Lillian Schmitt Elementary – Bid Package #2

Addendum #2

March 15, 2024

DRAWING NUMBER
C801

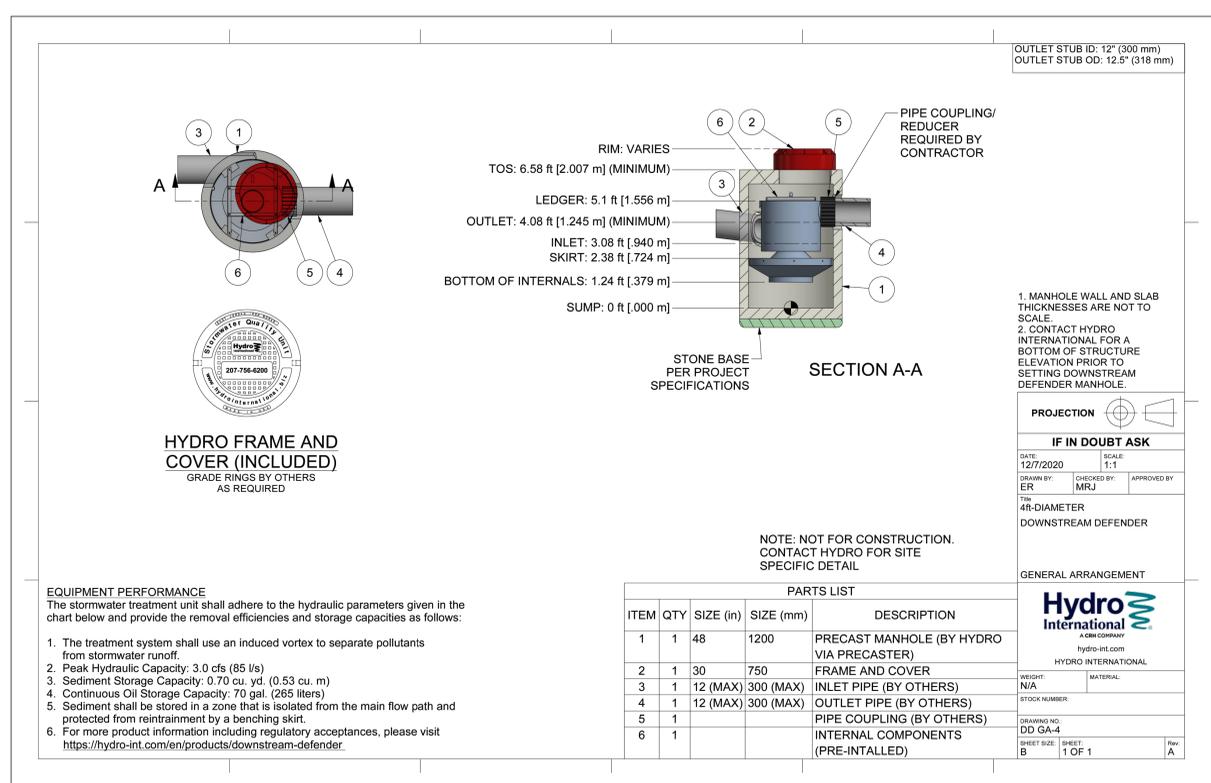
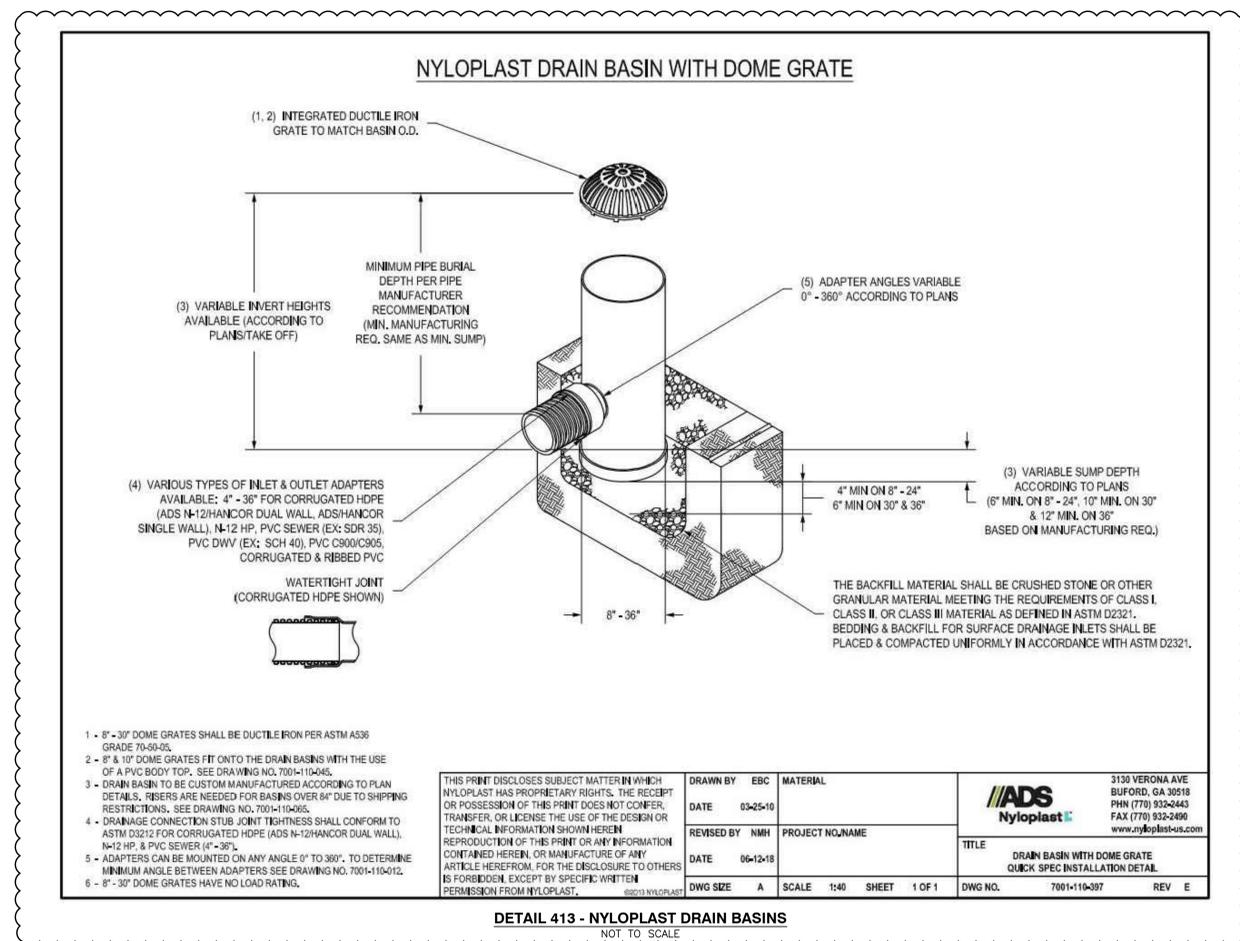
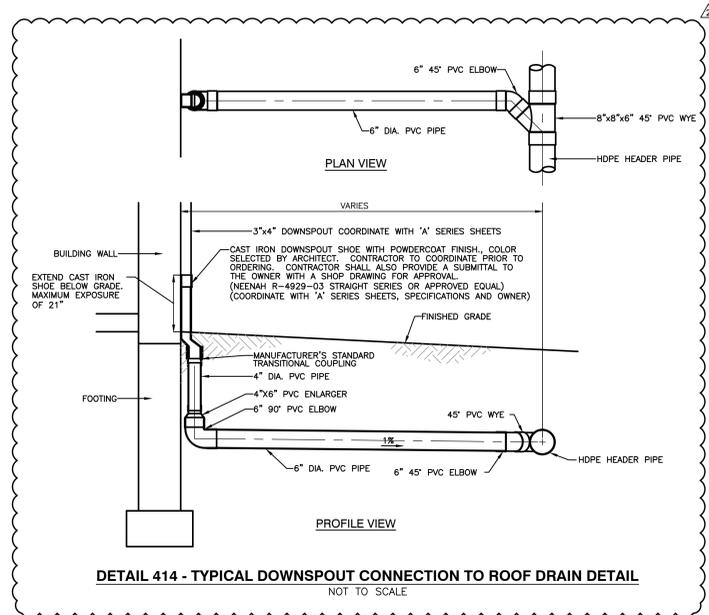
- S. Modify name of the sheet.
- T. Add detail for Nyloplast structures and typical roof drain connection per City drainage comment.
- U. Add general note to reference City of Columbus Standard Details.

13 TYP. CORRIDOR PANEL SECTION DETAIL
A611 SCALE: 1" = 1'-0"

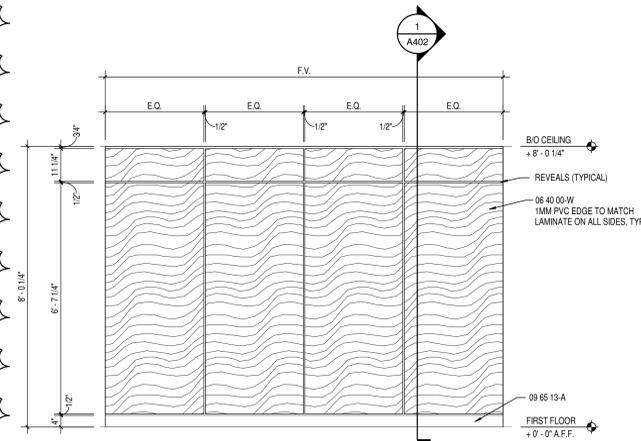
- A. Revise corridor panel drawings to reflect plastic laminate finish instead of wood and as shown on the attached sheet.
- B. Add additional keynotes and dimensions to 9/A611 – ENLARGED MILLWORK SECTION and 8/A611 – ENLARGED MILLWORK SECTION for clarity.
